**JOYCE MOTORS CLARENDON
PROPOSED SECTOR PLAN & ZONING ORDINANCE MODIFICATIONS**

November 9, 2020

PROPOSED SITE SECTION AND TAPER PLANE

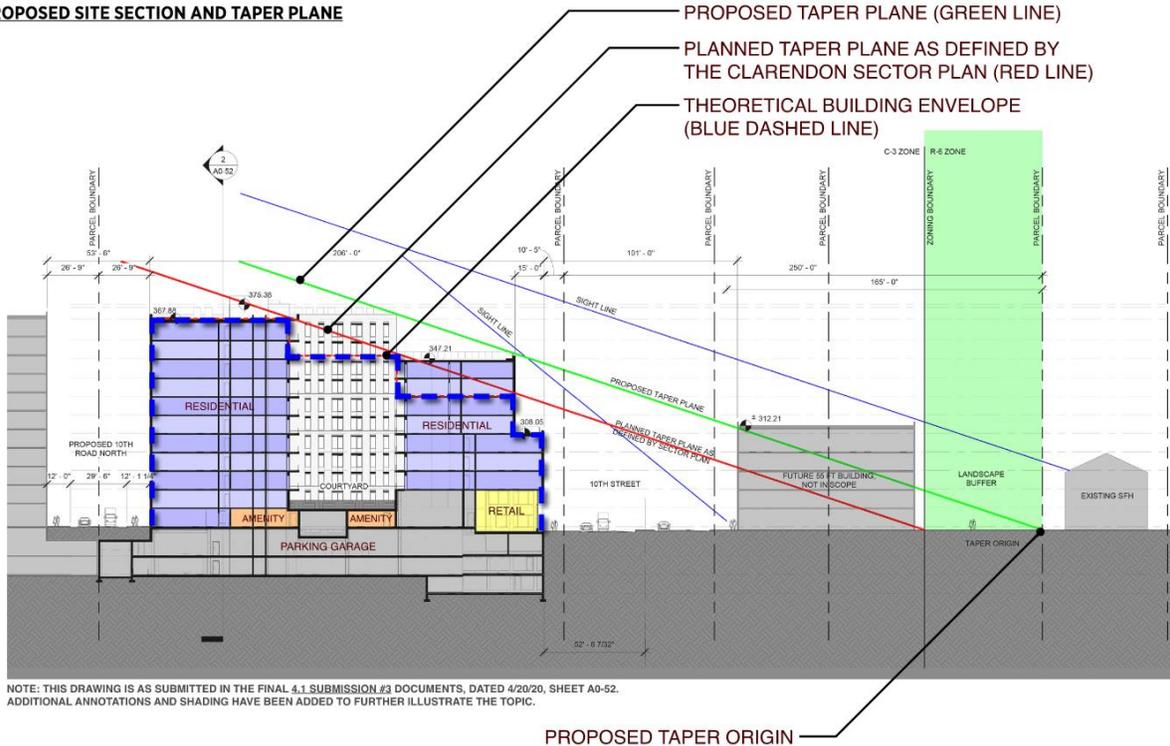
- Proposed Modification: Measure the height taper from the edge of property developed with single-family homes to the south of the project *rather than* the border of the nearest R- and RA-zoned districts. The proposed change would require a Zoning Ordinance text amendment to § 9.2.5 of the Zoning Ordinance.

- Justification: The purpose of the Zoning Ordinance’s tapering measurement was to protect the sight lines of, and encourage context-sensitive development adjacent to, R- and RA-zoned properties. The nearest single family homes are farther south from the Property than the border of the area zoned to the R-6 zoning district. The Sector Plan envisions that the commercial parking lot occupying this property could be subject to a future rezoning and redevelopment in accordance with the Sector Plan. The Sector Plan envisions a 55-foot long building across 10th Street to the south of the Property. The sight lines from the pedestrian level would block any views of the proposed building from the established single family homes.

The Sector Plan envisions a 55-foot building across 10th Street to the south of the Property. The sight lines from the pedestrian level would hide the proposed setback, as noted below:
